1963 Corvette: Service Bulletin: Interim Production Changes

Subject: Interim Production Changes
Model and Year: 1963 Corvette
Source: Chevrolet Technical Service Bulletin
Bulletin No: DR #569
Section: XV
Date: December 31, 1962

PARKING BRAKE LEVER ASSEMBLY REPLACEMENT

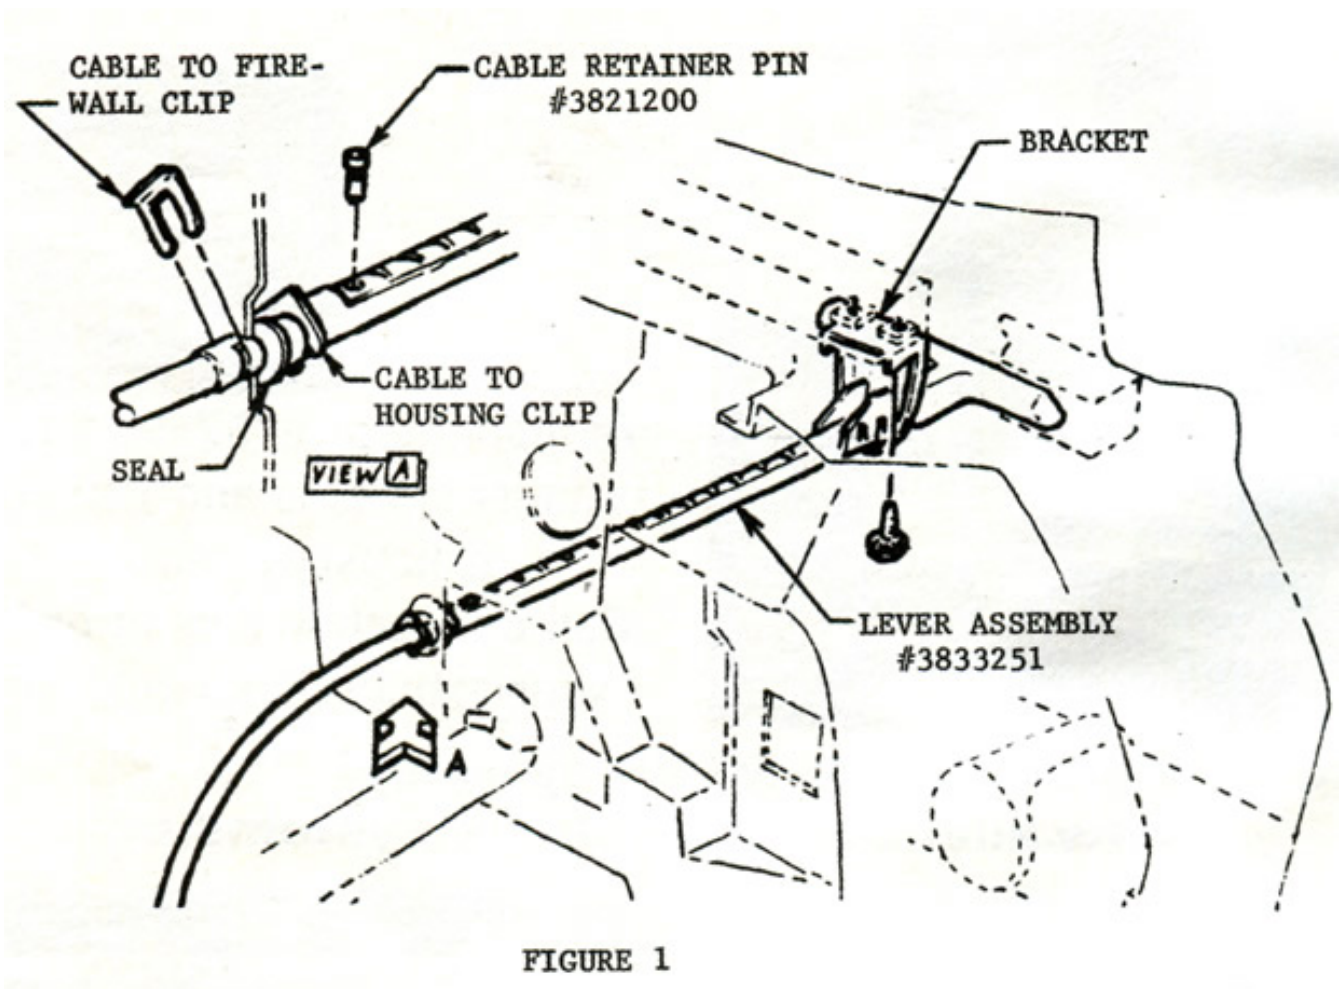
1. Effective with Serial No. S101893, a redesigned parking brake lever assembly entered Production. Early vehicles incorporate a lever assembly which may be difficult to release and in extreme cases, may actually jam making release impossible.
2. Vehicles with Serial No. S101847 through S102667, were built with a second design rear axle driveshaft flange that may not seat properly in the rear wheel drive spindle flange. An interference condition at this location could possibly lead to early failure of the rear wheel spindle flange attaching bolt bosses.

Lever Assembly should be replaced on all vehicles built prior to Serial No. S101893. Referring to Figure 1, proceed as follows:

1. Scrape sealer away from cable to firewall clip and remove clip.
2. Disconnect parking brake cable clip from steering gear retainer bolt.
3. Disconnect oil pressure line at gauge and pull line out of parking brake lever assembly bracket.
4. Remove two (2) bolts holding bracket to dash brace.
5. Pull complete lever and cable assembly to the rear, far enough to remove parking brake signal switch.
6. With handle all the way in, cable retainer pin will line up with hole in bottom of housing allowing pin to be driven out from bottom with a punch.
7. Remove cable to housing clip and separate cable from housing.
8. Install original seal on new lever assembly No. 3833251.
9. Reassemble by reversing the above steps using new cable retainer pin No. 3821200. NOTE: Chamfered side of pin must face forward to

FIGURE 2

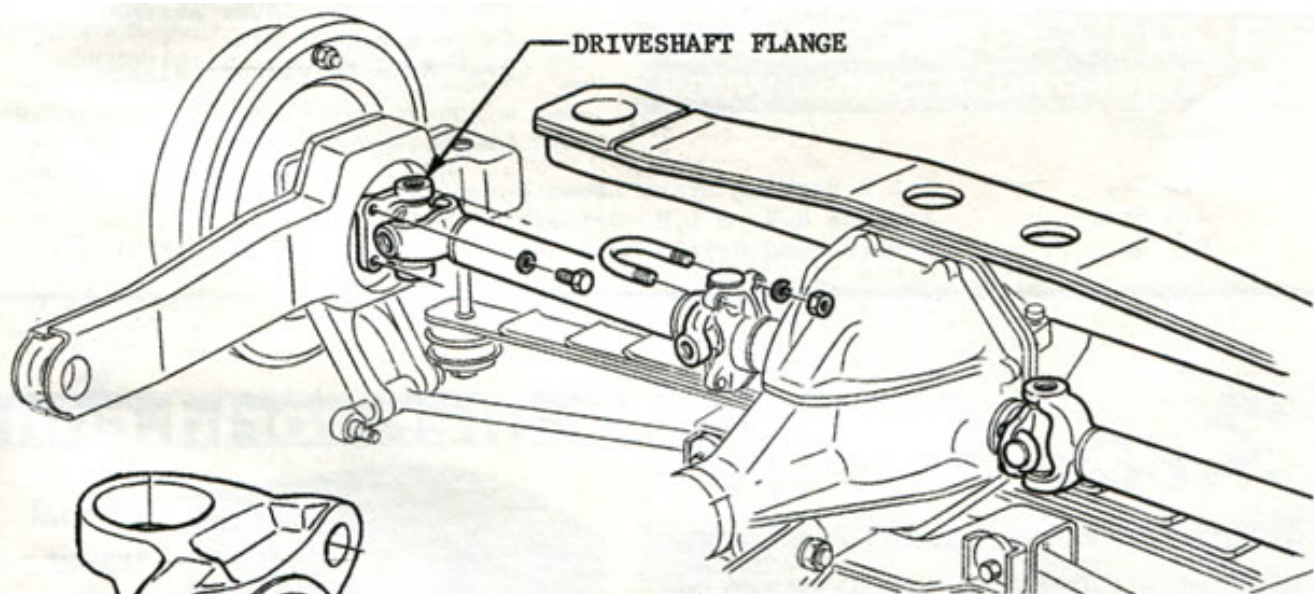
New machined Driveshaft Flanges No. 3832048, should be installed on all vehicles with Serial No. S101847 through S102667 (Ref. Figs. 2 and 3).

Replacement of the driveshaft flange is covered in the 1963 Corvette Shop Manual, Page 4-16. The rear wheel spindle flange attaching bolt bosses should be visually inspected while the axle driveshafts are out of the vehicle. Replace with new Spindle Flange Assembly No. 3830253 if any cracks are evident in the area indicated in Figure 4.

FIGURE 3 - DRIVESHAFT FLANGE

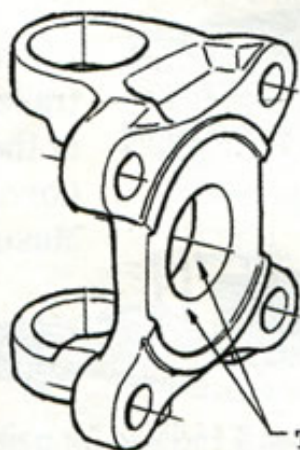
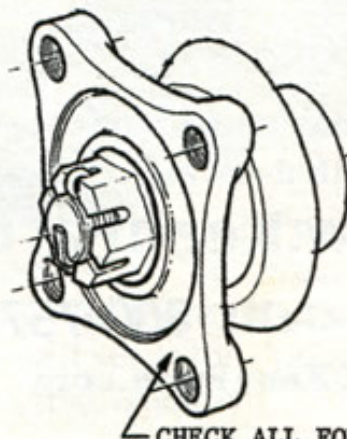
THESE SURFACES
MACHINED FOR
CLEARANCE

Vehicles built after S102667 incorporate selective fit pieces or additional machining to insure adequate clearance.
